[Docket No. FAA-2004-19960; Directorate Identifier 2004-CE-47-AD]

Airworthiness Directives; The New Piper Aircraft, Inc. PA-34 Series Airplanes

ACTION: Notice of proposed rulemaking (NPRM).

Figure 1

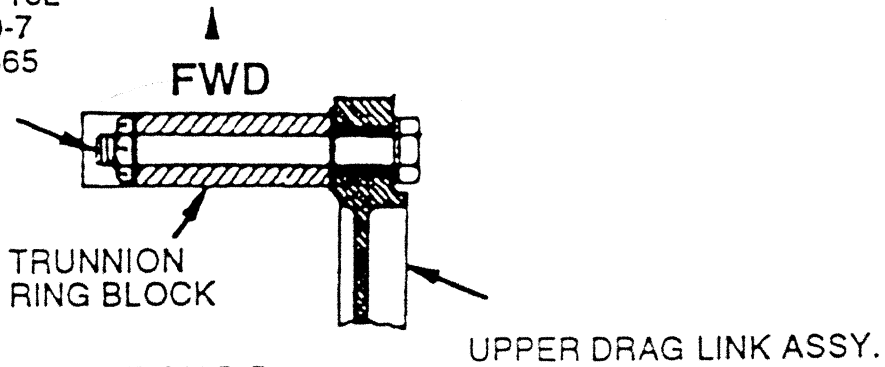
Actions	Compliance	Procedures
(1) Replace the bolt and stack up that connects the upper drag link to the nose gear trunnion with new parts of the following: (i) Piper part number (P/N) 400 274 (AN7-35) bolt; (ii) Piper P/N 407 591 (AN960-716L) washer, as applicable; (iii) Piper P/N 407 568 (AN960-716); (iv) Piper P/N 404 396 (AN320-7) nut; and (v) Piper P/N 424 085 cotter pin.	Within the next 100 hours time-in-service (TIS) after January 28, 1994 (the effective date of AD 93-24-14), unless already done within the last 400 hours TIS before January 28, 1994 (compliance with AD 93-24-14). Repetitively replace thereafter at intervals not to exceed 500 hours TIS. Continue to repetitively replace until the actions in paragraph (e)(2) and (e)(3) of this AD begin.	Follow Figure 1 of this AD.
